Item VII.

Metro Planning Commission Meeting of 11/14/06

Proposed Westin project looking East down Lower Broadway

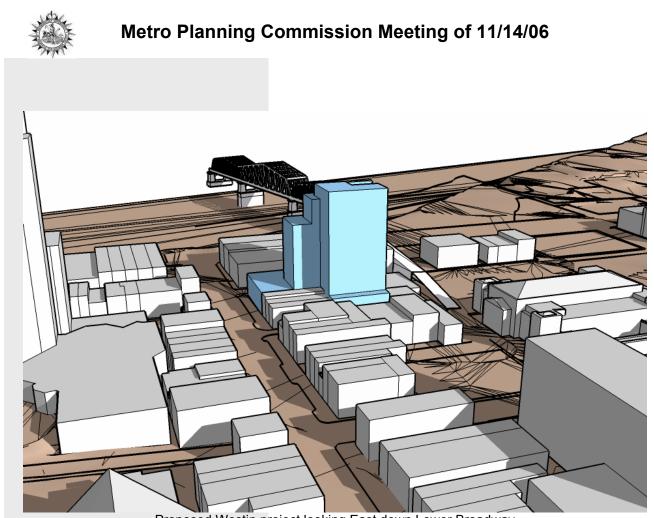
Windows should align with others in a block similarly to the historic structures along Lower Broadway. Windows, lintels, and window trim elements should align with the historic buildings on the block, and the current Westin submittal does not. The current Westin submittal has translucent panels and glass curtain walls and these are not window configurations or materials historically seen along Lower Broadway.

The repetition of recessed building entries occurring along the street in the Lower Broadway historic district provides a rhythm of shadows along the street, which helps establish a sense of scale and invites pedestrians to enter buildings. This trend should be continued in the Westin's new construction and building entrances from Broadway should appear similar to those used historically. The Lower Broadway Historic District should continue to develop as a pedestrian-oriented environment of ground floor storefronts. Buildings should relate to pedestrians by using materials and a human scale compatible with local historic patterns.

A bulkhead (or kickplate) is a key defining architectural feature on most commercial buildings and should be added to be consistent with the district. The proposed storefronts need bulkheads (kickplates). Additionally, the glass guardrails shown at the balconies are not consistent with historic architectural precedents.
